MEMORANDUM

SUBJECT: Sketch Plan Approval – 904 Leray Street

DATE: September 28, 2023

Request: Sketch Plan Approval to construct a 783 square-foot (SF) building addition at 904 Leray Street, Parcel Number 2-11-118.100

C100

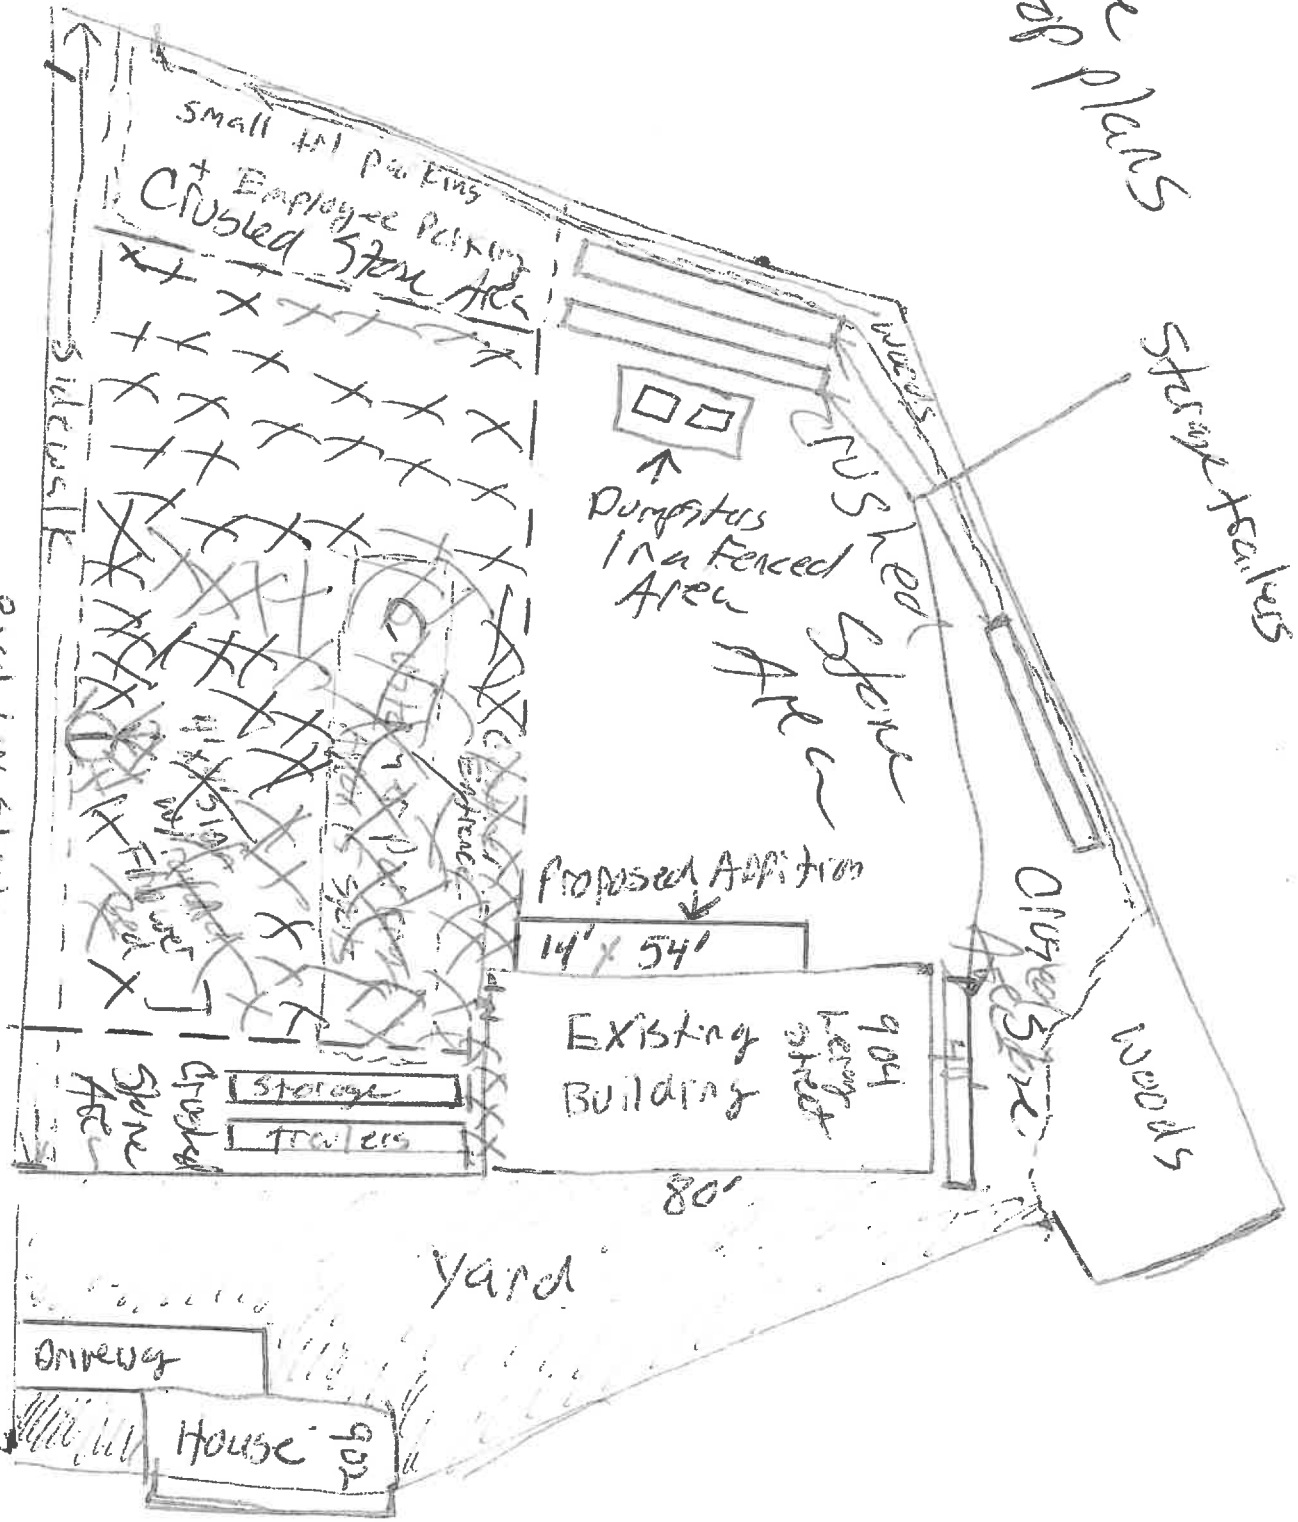
Project Overview: The applicant proposes to construct a 14’5” x 54’4” (783.44 SF) building addition on the north side of the existing Makes Cents Redemption Center at the subject address. The applicant is not proposing any other improvements currently. However, the applicant has also communicated to Staff an intent to pave the majority of the parking area on the parcel in 2024, an activity that would, without exception, require a full Site Plan Approval.

Lighting: The applicant did not submit a photometric plan. There are existing light packs mounted on the northeast and northwest corners of the redemption center building. The proposed building addition does have potential to affect what areas these light packs illuminate. The applicant should be prepared to answer questions about adequate illumination should the Planning Commission have any inquiries.

1. The applicant should be prepared to discuss how the proposed building addition will affect exterior illumination of the north side of the building from the mounted light packs currently installed at the northeast and northwest corners of the existing building.
2. The applicant must obtain a Building Permit prior to construction.
